March 1, 2024 questions and requests for information from Eversource on X-178 line:

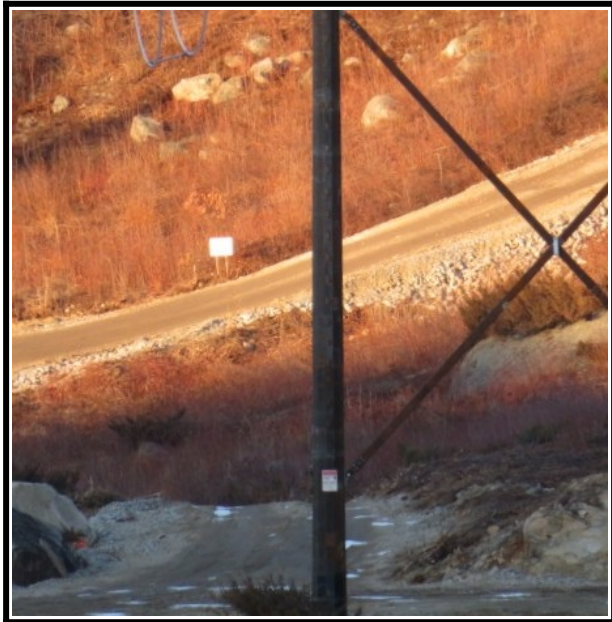
Has Eversource informed any easement-encumbered landowners that they must request that soils excavated from their easement property be left, rather than trucked away by Eversource?
